**A Preliminary Tree Protection Plan  
1958 Latham Street  
Mountain View, California**

**A Comparative Impact Study  
Between Two Design Site Plans  
1958 Latham Street  
Mountain View, California**

I was asked by Yin Su, Project Architect, Barry Swensen Builder, to prepare an impact study between Site Plan Option 1 and Site Plan Option 2 with regard to the canopy loss of the large oak Tree # 2 at 1958 Latham Street, Mountain View, California. The primary question was whether or not the canopy loss to Tree # 2 would be significantly different between Option 1 and Option 2.

Comparative Study of Canopy Loss  
Sketch of Tree Primary Scaffolding Structure

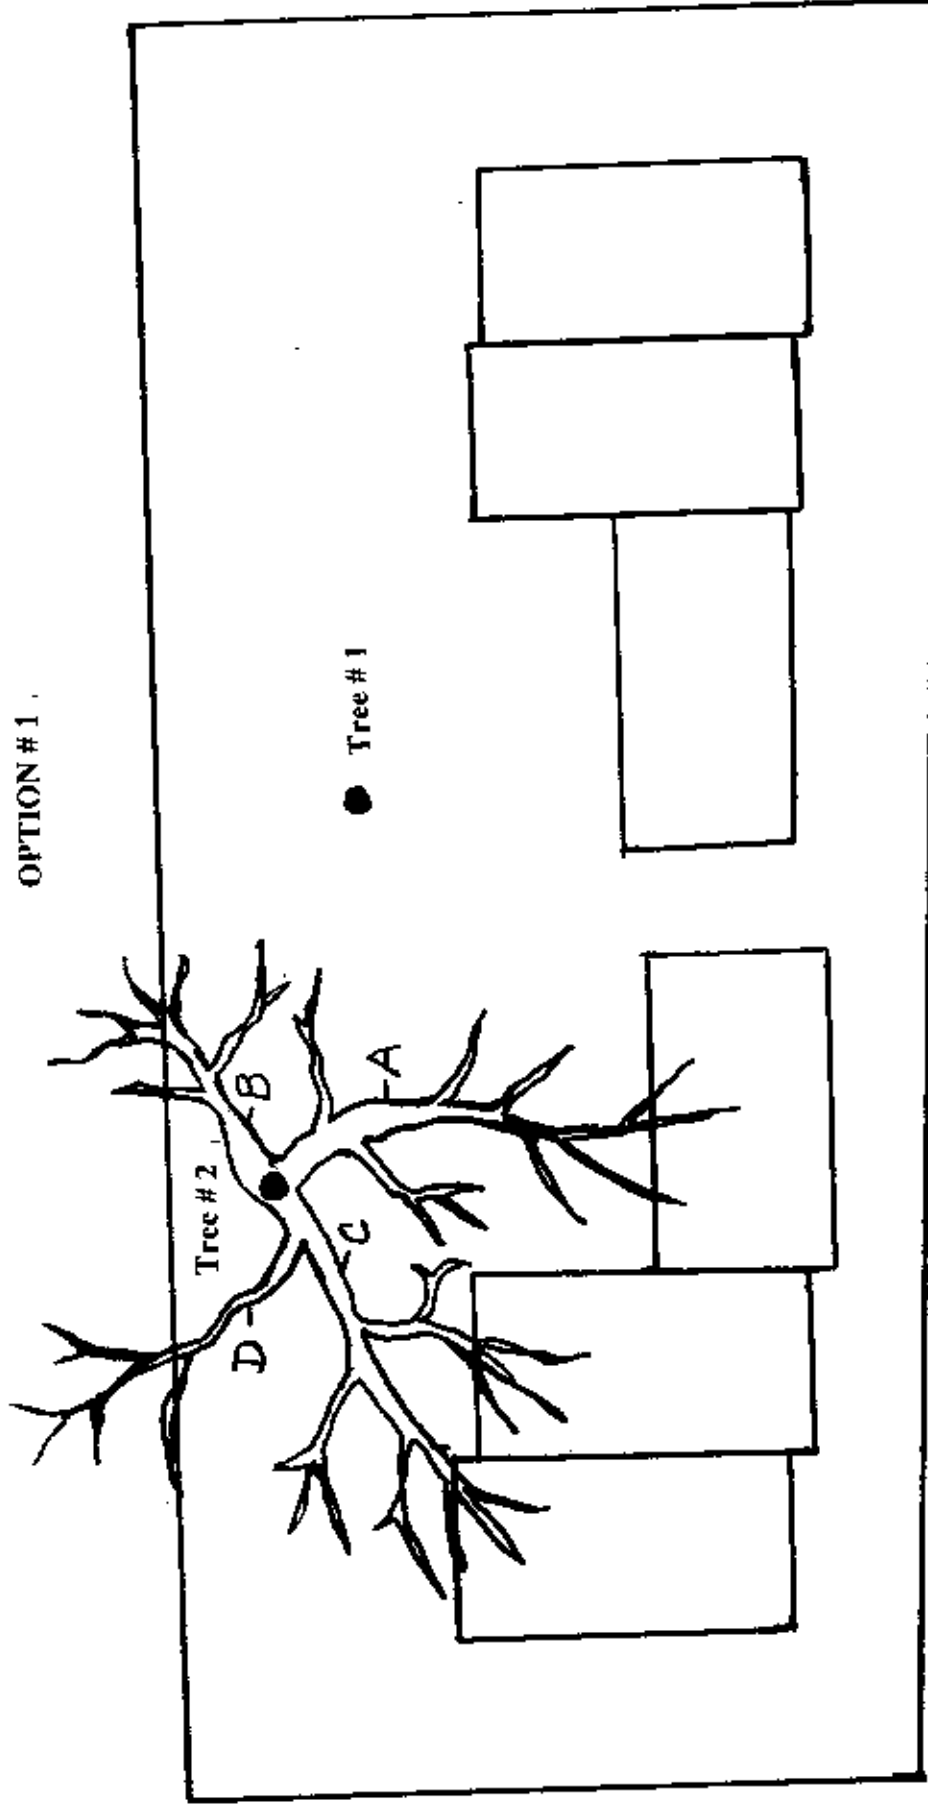
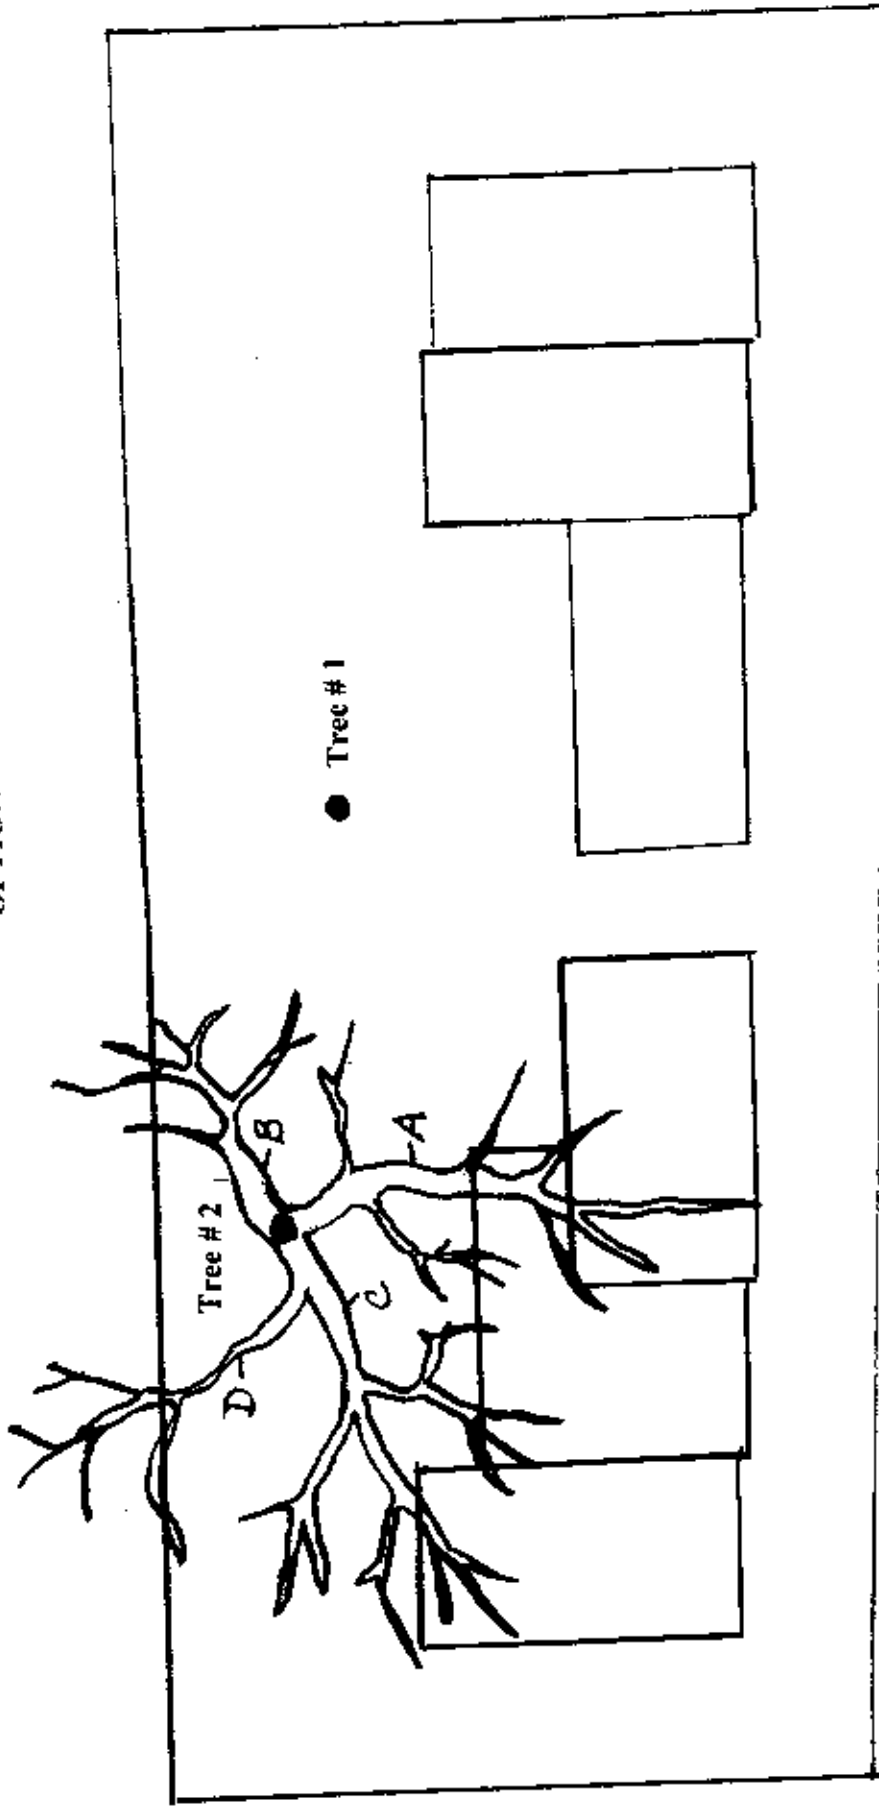
Obviously Tree # 2 would experience some canopy losses by each of these designs. The significant difference is that the Leader A would be severed at 10-12 feet from the trunk of Tree # 2 should Option 2 be construction. This would result in a stub cut or “topping” cut on Leader A leaving a stub approximately 15-17 inches in diameter. Almost all of the live canopy on Leader A would be removed by making this cut. Because Leader A has a relatively high percentage of the total canopy, I estimate that the removal of Leader A would be a reduction of approximately 1/3 of the total canopy.

By comparison, the canopy loss to Tree # 2 by the construction of Option 1 would be greatly reduced. Per this Option, I estimate that the largest wounds would be 2-3 inches in diameter. Overall I estimate that the total canopy loss to Tree # 2 by the construction of Option 1 would be approximately 15%, which is well within industry standard.

The canopy loss to Tree # 2 by the proposed Option # 2 would be approximately 30% by my estimate, but the mere percentage loss does not adequately express the loss. The majority of this loss would be by the removal of one of the primary leaders, which would in time develop into a major trunk cavity. Not only would this tree be badly disfigured, but it could be the beginning of the end for this tree, recognizing that these types of events take a long time to reach full development.
